16 April 2026

Pre-Development Application No:	PR2026/01016 (SSD-89869959)
Land:	Lot 1 DP 1197377
Property Address:	10 Dangar Street Wickham
Proposed Development:	Construction of a 43-storey (plus plant) mixed use tower, comprising residential apartments, co-living apartments, ground floor retail, hotel component and concurrent rezoning proposal via a SSD application.

2.1 Height & FSR

Figure 1 – Extract of existing stormwater details Source Onemap

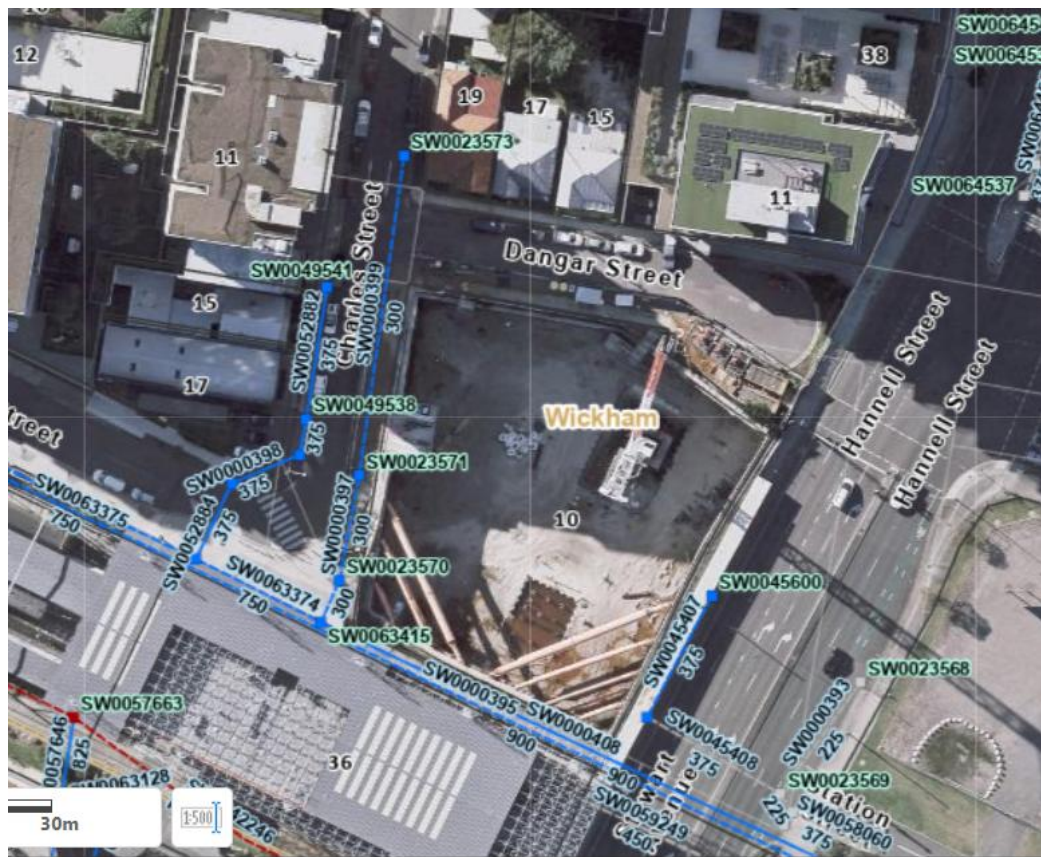
There is existing underground road drainage along Station St and the through link (see **Figure 1** below). CN notes that the previous approved developments on this site were designed to retain the existing drainage pipe and structures.

It is expected that, at minimum, concept civil and stormwater plans will be prepared and submitted to relevant authorities for review and approval including CN.
